**TOWN OF GLASTONBURY**  
GL-2019-30  
FACILITIES MAINTENANCE BUILDING EMERGENCY SERVICES MODIFICATIONS  
ADDENDUM NO. 1  
03/27/19

The attention of bidders submitting proposals for the above-referenced project is called to the following Addendum to the specifications. The items set forth herein, whether of omission, addition, substitution or other change, are all to be included in and form a part of the proposed Contract Documents for the work. Bidders shall acknowledge this Addendum on the Bid Proposal Page (BP-1).

Revision	Description	Date	Revised By
REV #1	ADDENDUM #1A	3.26.19

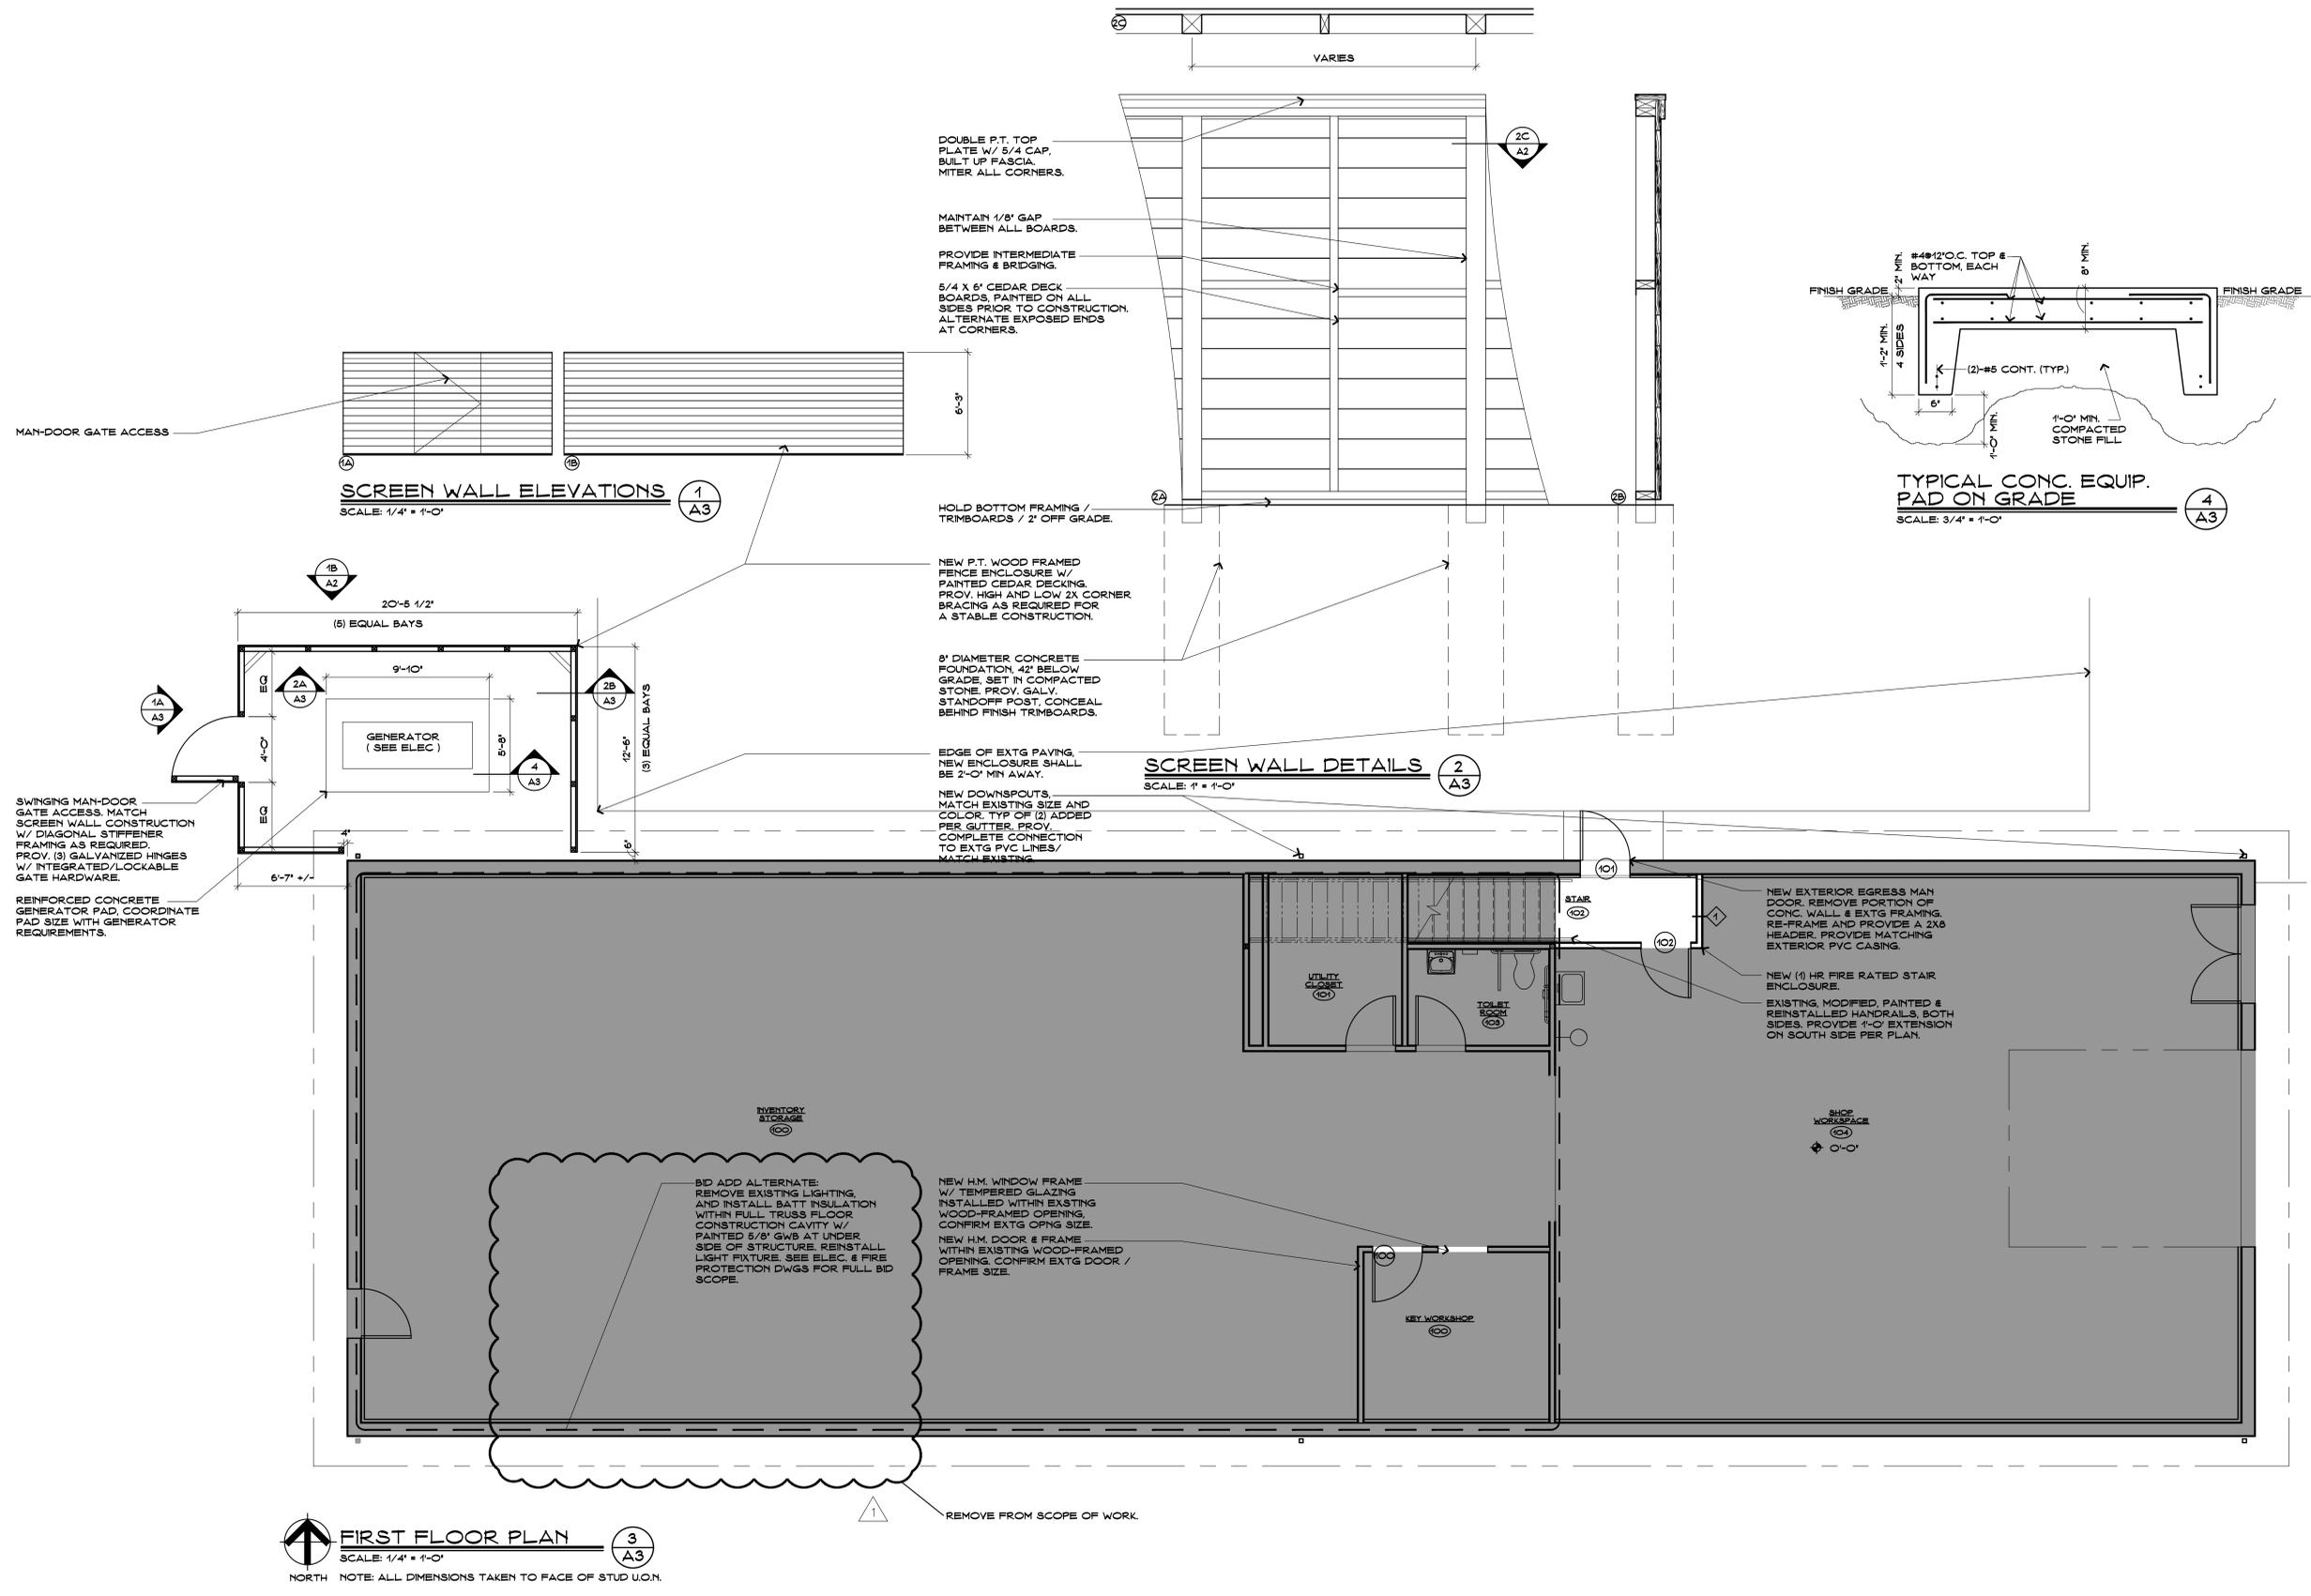
**Question 7:** *It was mentioned that the current scope of work differs from what is shown on the drawings and that we should use the bid form to determine what we need to bid on. I see that there is no spot on the bid form for alternate #1. Does that mean that this alternate is gone and no longer part of the project or does it mean that it is now part of the base bid? There is also no line item for "Electrical". Does that mean that there is no electrical work as part of this project (e.x. new exterior lighting adjacent to newly installed personnel door)? Can the drawings be revised to reflect what the scope of work actually is (maybe as easy as crossing off the items on the drawing that have been removed) or at least a well-detailed scope of work be provided?*

**Answer:** Any work listed as Alternate #1 is Not In Contract. Electrical work associated with the rated staircase and entry is included. Revised drawings A3 & A4 attached.

**SECOND FLOOR PLAN**  
 SCALE: 1/4" = 1'-0"  
 NORTH NOTE: ALL DIMENSIONS TAKEN TO FACE OF STUD U.O.N.

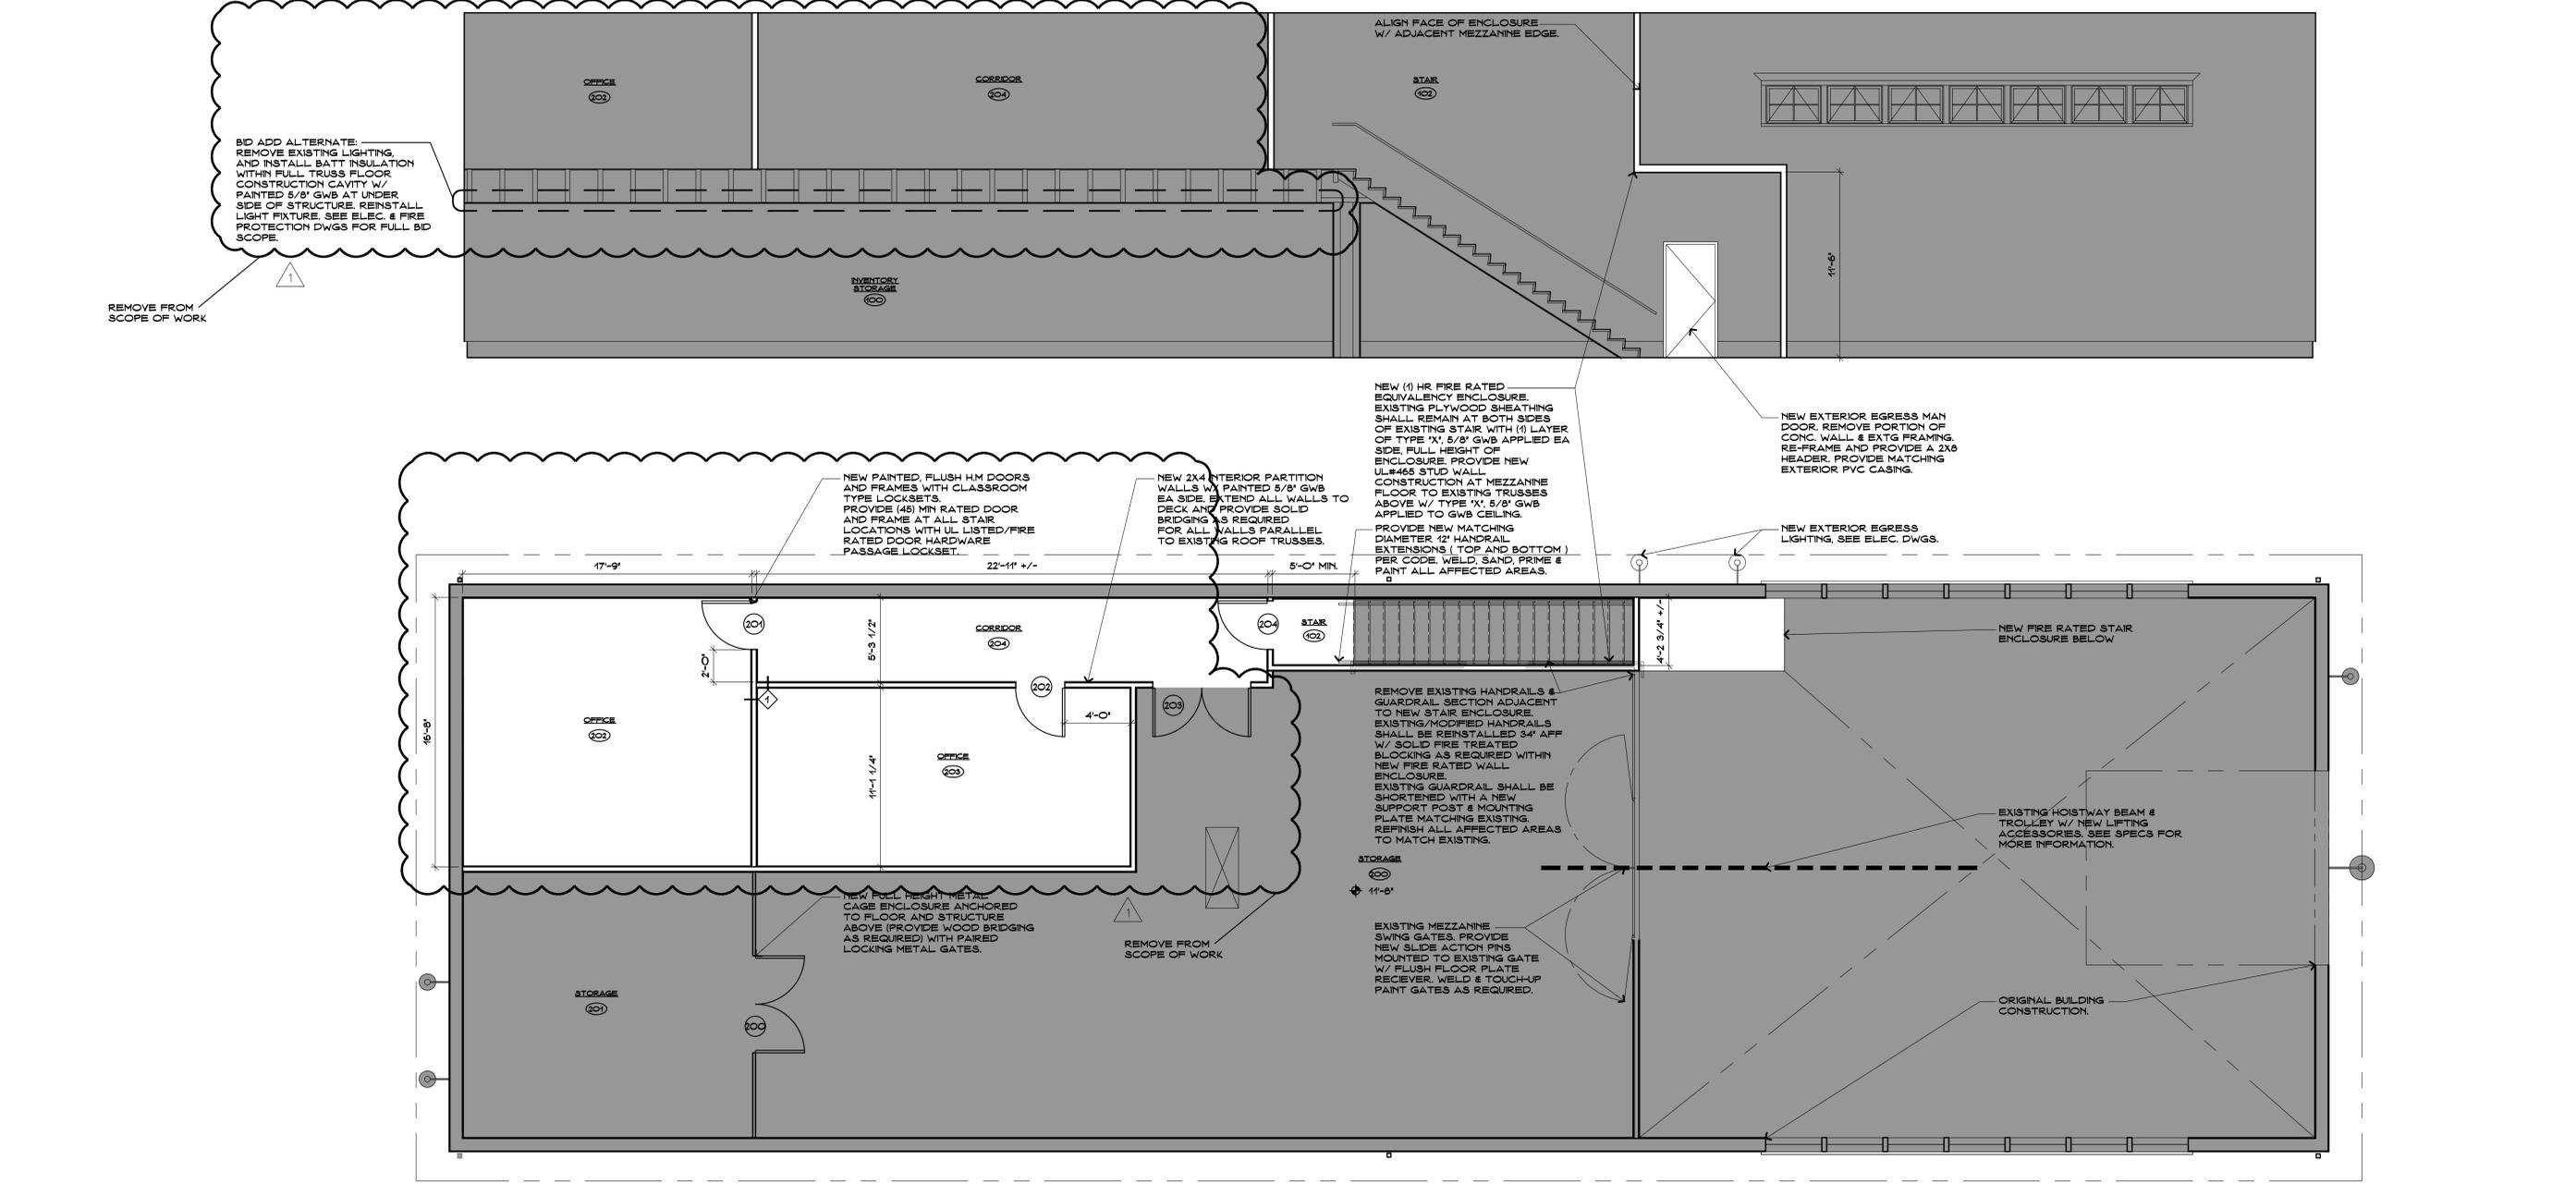
**Question 11:** *2nd floor offices and corridor? - Are these part of the scope?*

**Answer:** Rooms 202, 203 and 204 and associated doors are Not In Contract.
